Access Compliance Report

Public Rights-of-Way

| Intersection ID: 29375 | Main Street: BUCKVALLEY_DR | Cross Street: ROBANNA_CT | Location: SE |
| ADA ID: CD463D744F08 | Ramp Type: PerpDiag | Initial Pass/Fail: Pass | Overall Compliance: No |

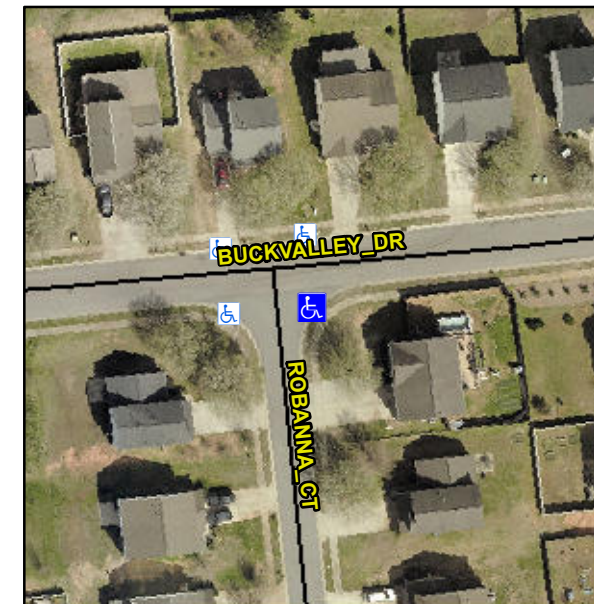
R304.2.1, R304.2.2-Perp, R304.3.2-Para, R304.5.3, R305.2

| Compliance | Description | Data | Compliance | Description | Data |
|------------|-----------------------|--------|------------|-----------------------------|------|
| No | Landing Length (in) | 44.0 | Yes | DWS Provided? | Yes |
| No | Landing Slope (%) | 4.6 | Yes | DWS Length (in) | 24.0 |
| No | Landing X Slope (%) | 2.7 | Yes | DWS Full Width? | Yes |
| N/A | Landing Curb? (Y/N) | No | No | DWS Offset (in) | 5.0 |

Remove & Replace Curb Ramp With Two New Directional Ramps or Equivalent.
